## Memorandum

TO: Board of Public Works

RE: Request to Install Crosswalk on Garfield Avenue at Mondri Akrosil LLC

PROPOSED  
CROSSWALK

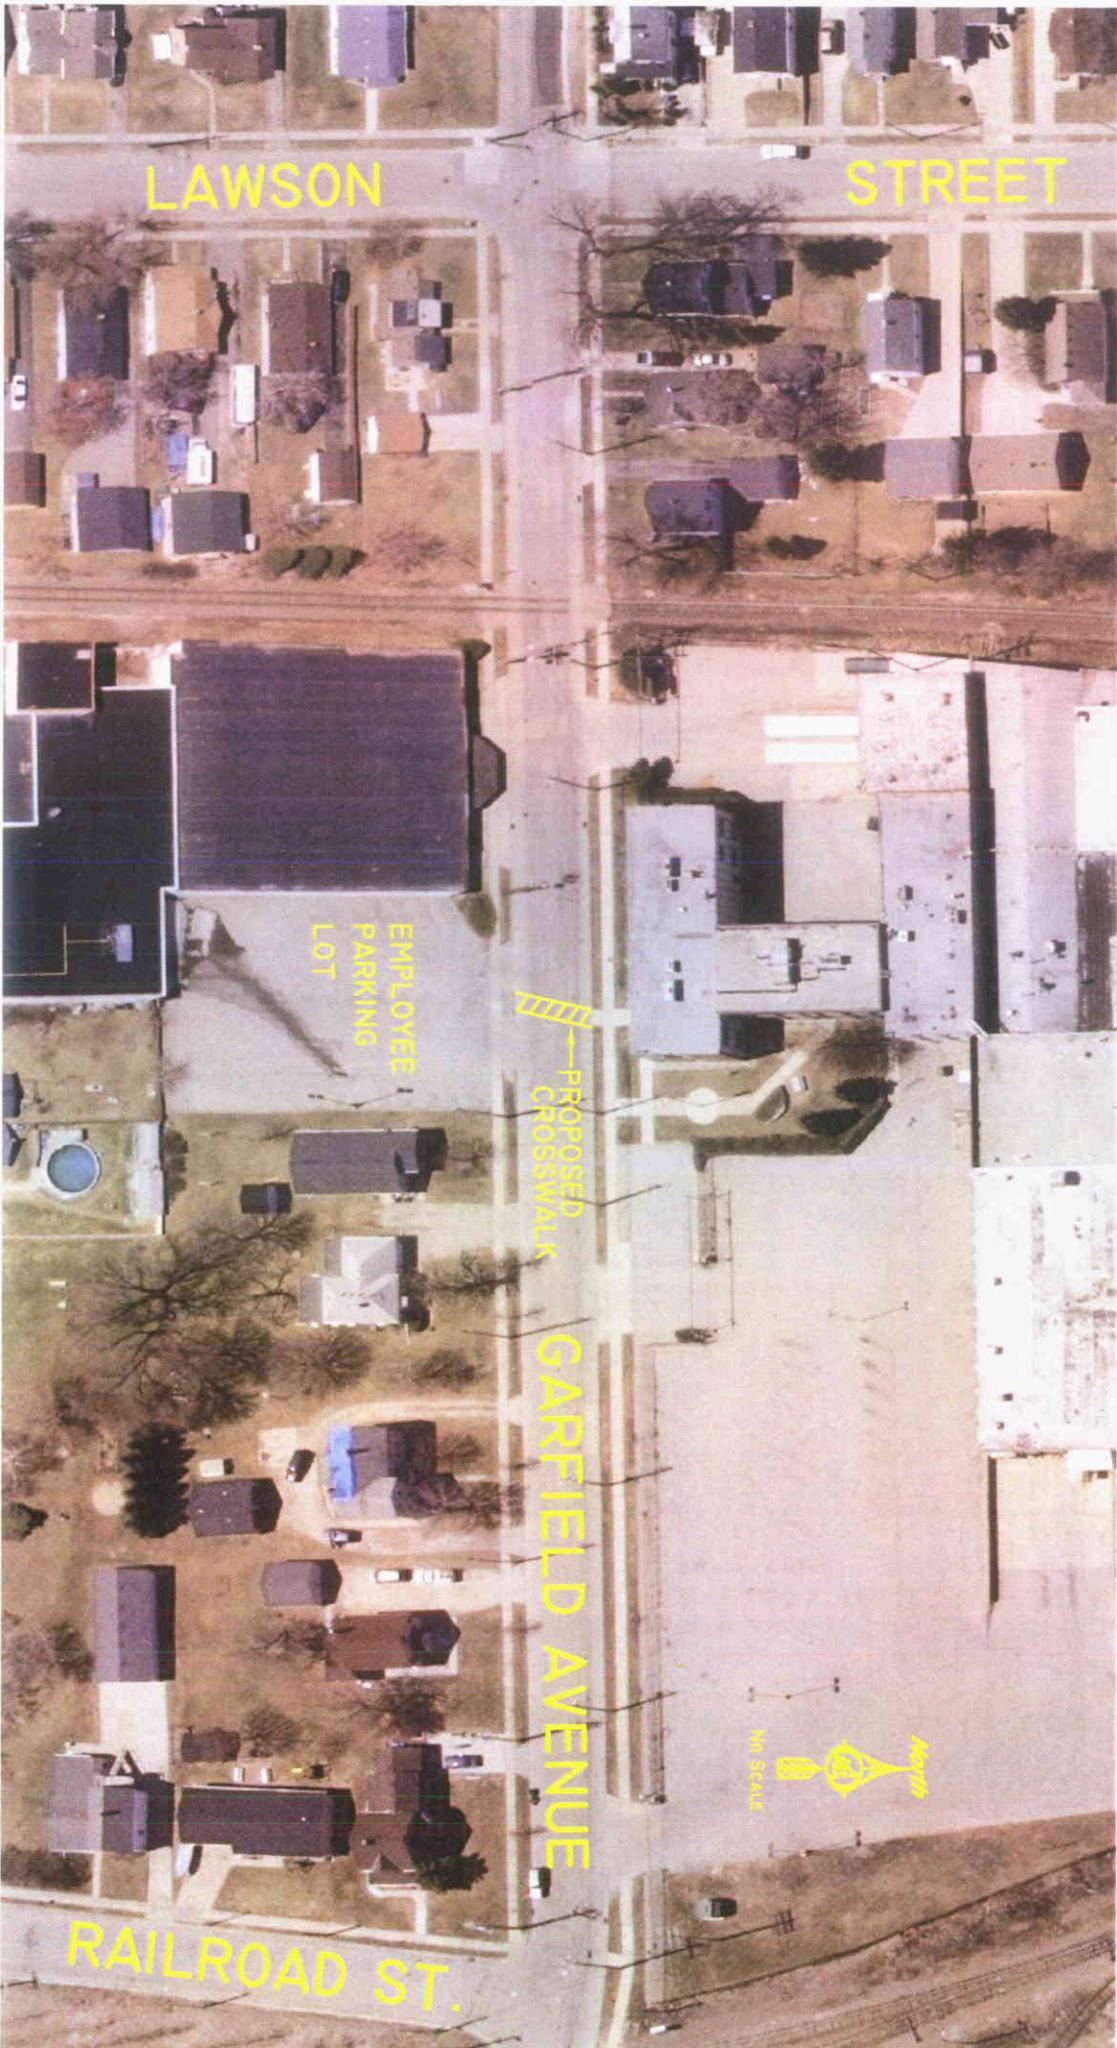
Attached is a request from the Safety Coordinator of Mondri Akrosil requesting a crosswalk be installed across Garfield Avenue connecting the main office employee entrance to the employee parking lot. The request is being made as a safety concern for the employees mainly due to the existence of truck parking along both sides of Garfield Avenue in the vicinity of the crossing point.

Regarding mid block pedestrian crossings, the American Association of State Highway and Transportation Officials (AASHTO) provides for their use at appropriate locations and with the proper warning signs and parking conditions. In this case, the location of the requested crosswalk is at an appropriate location, given the distance from adjacent intersections and the focal point of the employee crossing area. In my opinion, however, the combination of relatively minor Garfield Avenue traffic volumes and limited number of employees parking in this lot do not warrant a mid block crosswalk. The average daily traffic on Garfield Avenue is 1,500 vehicles per day and the number of employees using this parking lot is approximately 45.

The request cites the frequent parking of trucks along both sides of Garfield Avenue in this vicinity. I do think this creates a safety concern for the employees crossing at this location due to restricted sight lines for both the pedestrian and the motorist. I would recommend the parking issue be referred to the Parking Committee for consideration of prohibiting parking in the immediate vicinity of the area at which employees cross Garfield Avenue.

I recommend the Board deny the request for a crosswalk at this location but forward the parking issues to the Parking Committee. If the crosswalk were authorized, I estimate the cost of the necessary curb replacement, walk ramp installation, signs and pavement marking to be \$1,050.
